DATE: APRIL 18, 2025
TO: ALL CONTRACTORS
FROM: JOSH PIERCE, P.E.
PROJECT: CWSRF WWTF IMPROVEMENTS
CITY OF MILLBROOK
CWSRF PROJECT NO: CS011059-01
GMC PROJECT NO: CMGM240007(1)
RE: ADDENDUM #3

ADDENDUM NUMBER 3

CWSRF WWTF IMPROVEMENTS
FOR THE
CITY OF MILLBROOK
SRF PROJECT NO: CS011059-01
GMC PROJECT NO: CMGM240007(1)

C-301

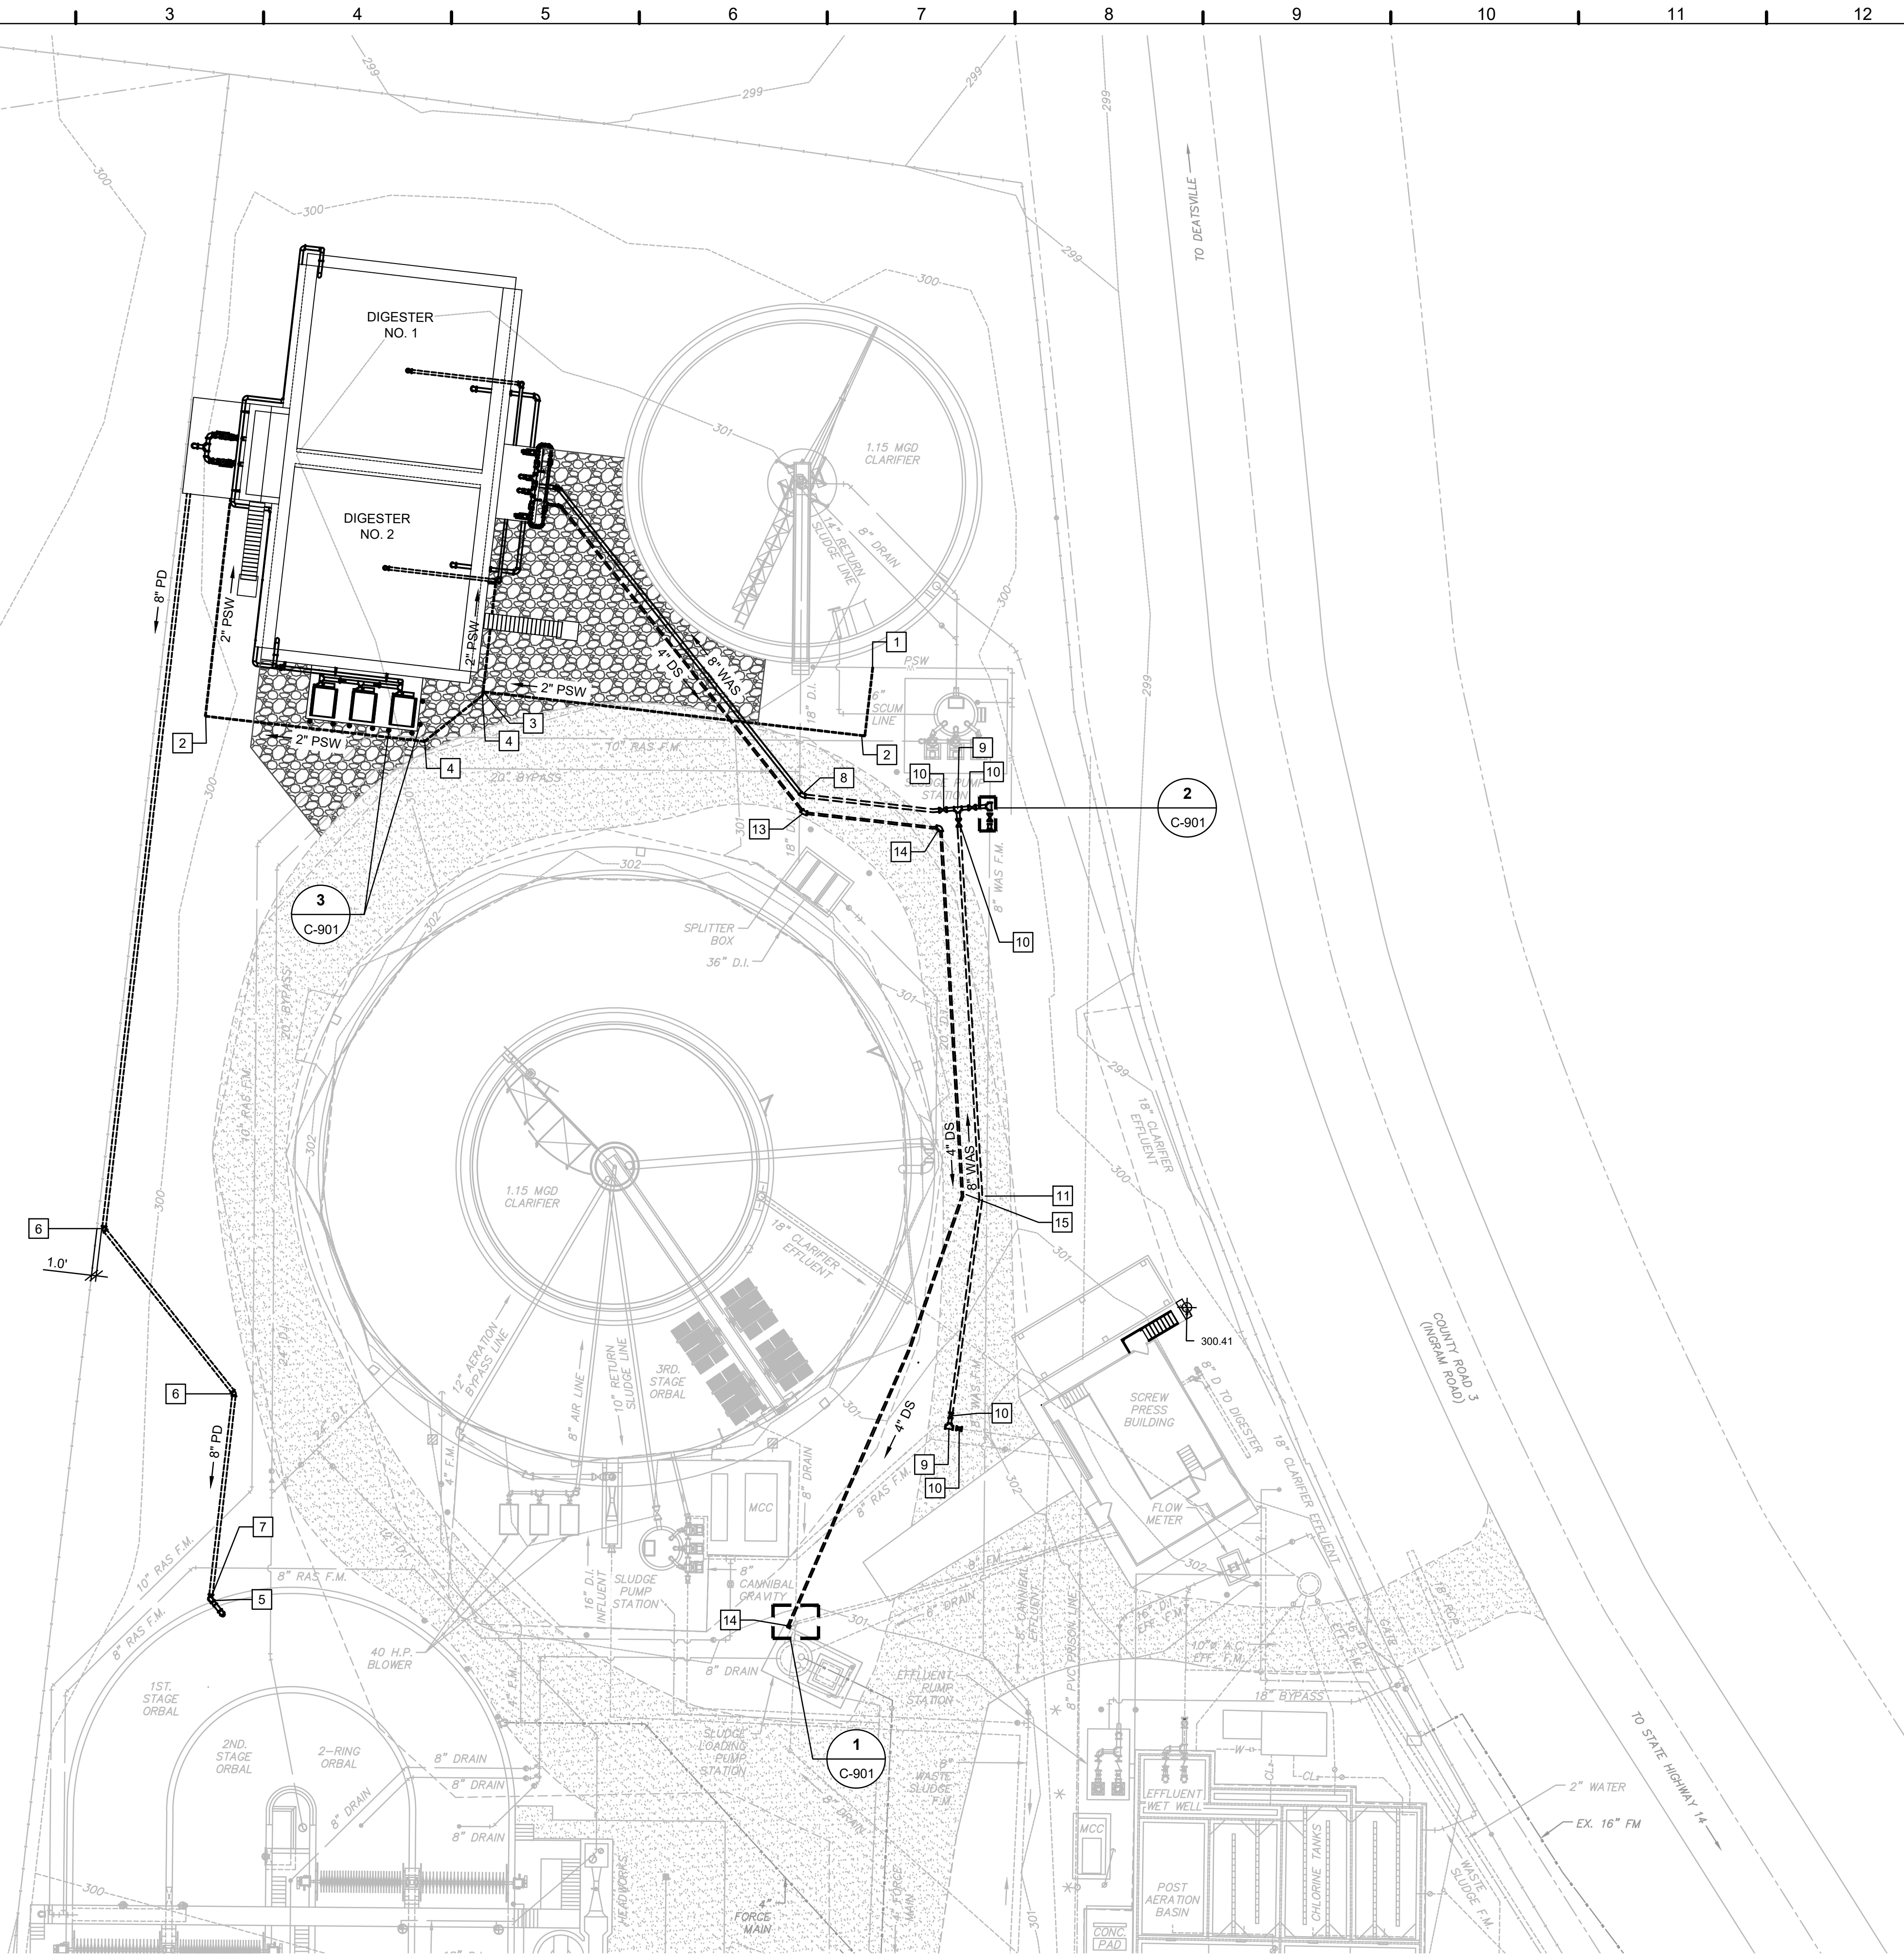
- 3.1 Question: Please confirm the 4" Plug Valve shown in Detail 1 on Drawing C-901 is V-8201?
Response: **Confirmed.**
- 3.2 Question: Drawings C-301 and D-001 appear to show a new valve (in bold text) adjacent to the Existing Sludge Loading Pump Station. Please confirm a valve is needed at this location and advise what size and of type of valve is required?

Response: **This valve is not recommended for replacement and is displayed in bold due to a printing error. Revised sheet C-301 should reflect this and offer clarity for what fittings are required in area of existing sludge loading pump station.**

9 GRAVEL PAVING
C-901 SCALE: NOT TO SCALE

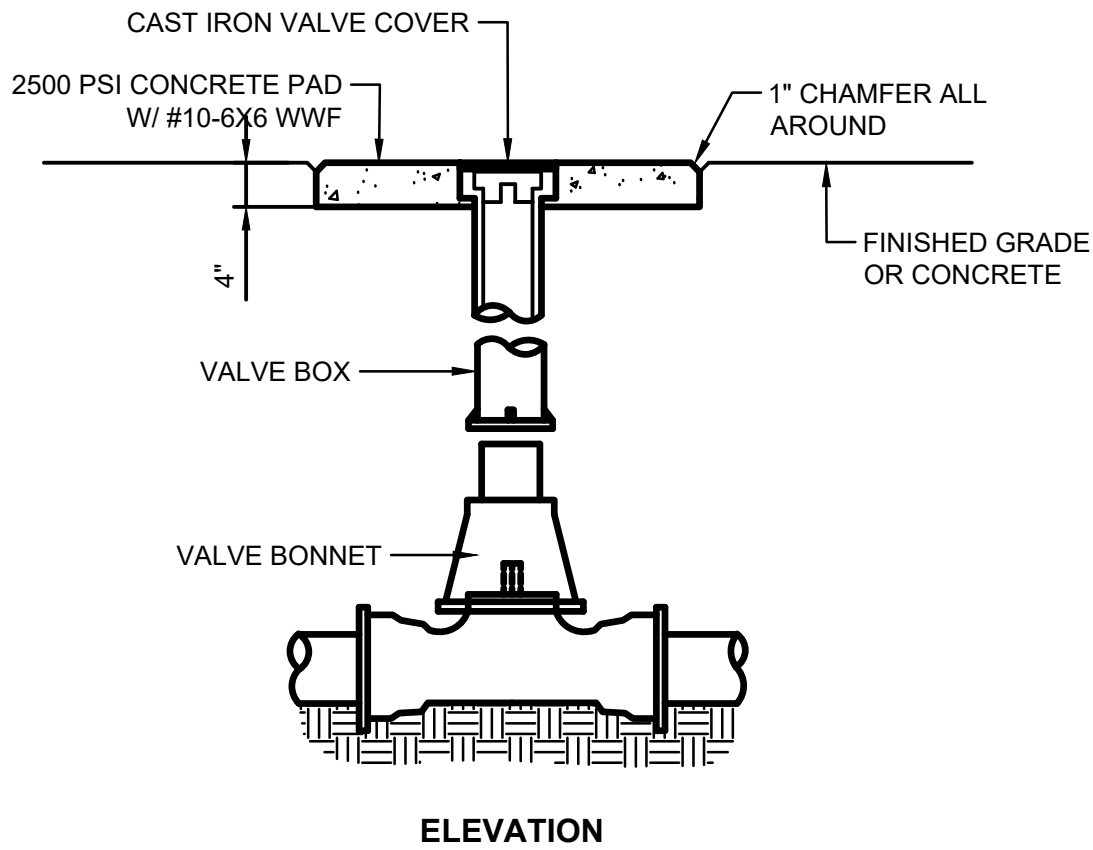
- 3.3 Question: Provide a Detail for Gravel Paving shown on Drawing C-201.
Response: **Detail is included in revised sheet C-901 attached.**
- 3.4 Question: Question: Specification lists a tube conveyor (HUBER model Ro8). Please confirm if trough style conveyor (HUBER Ro8T) is acceptable to match existing conveyor #1 in lieu of full tube listed in specification?
